Secretary Town Planning Board,
15/F North Point Government Office
No. 333 Java Road, Hong Kong
Date : 6 January, 2026

Re: Yan Tak Kwun at No. 45, Tan Kwai Tsuen Hung Shui Kiu, Yuen Long, New Territories (Lot No. 3971 RP (Part) in D.D. 124)

(Planning Application No. Y/YL-TYST/11)

Refer to the departmental comments on 3 July 2025, we now FINAL respond to the comments of Point (i) , Point (ii) and Point (iii).

APPENDIX A
TREE SURVEY PLAN

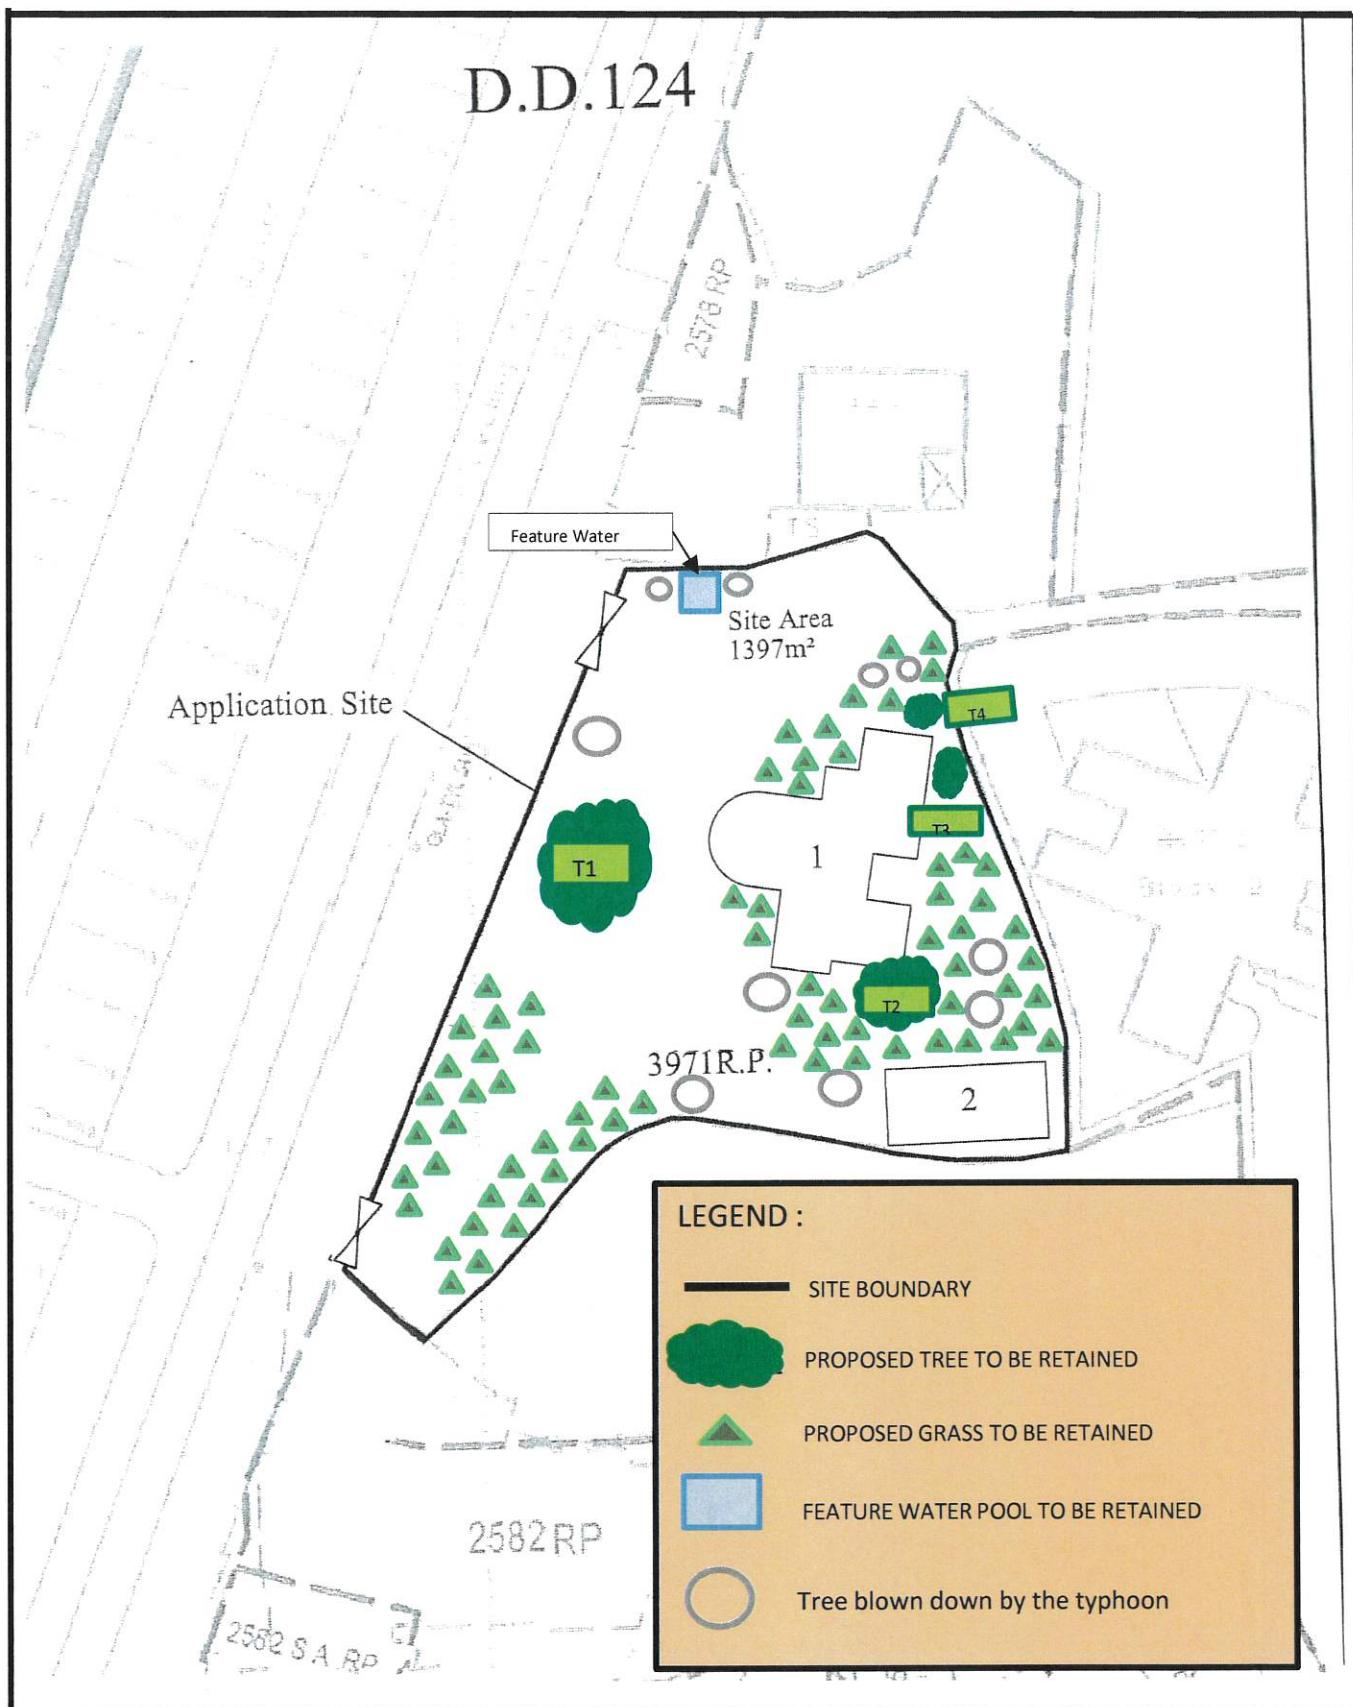
1. Point no.3 :

The Tree Survey Plan in APPENDIX A to illustrate the information that are up-to-date on existing tree , including the tree landscape and location.

APPENDIX D
LANDSCAPE MASTER PLAN

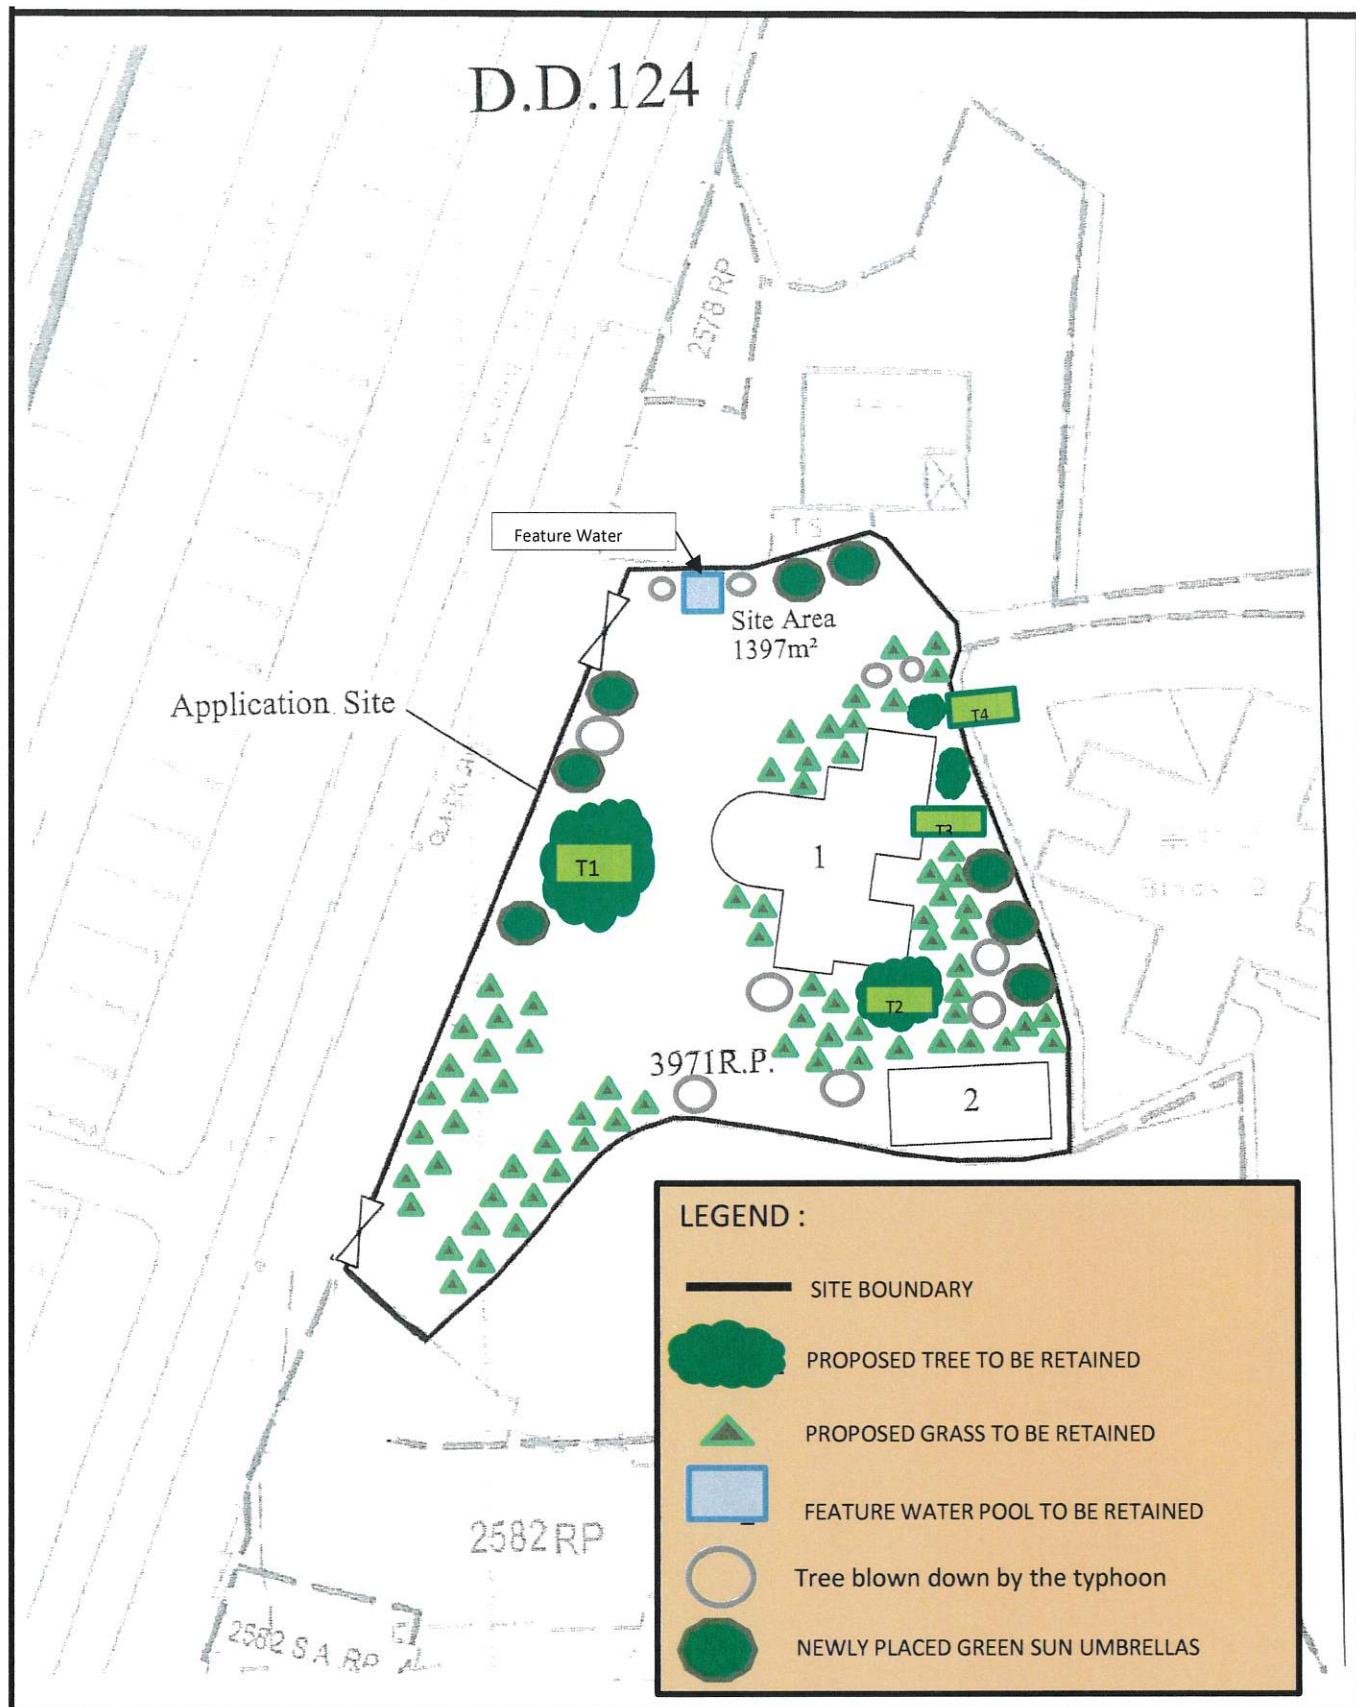
2. Point no.4 :

Landscape Master Plan in APPENDIX D is to respond to site conditions, both in terms of landscape character and visual amenity.

Add green sun umbrellas , protecting guests to provide a safe and healthy environment. It can also enrich the green landscapes.
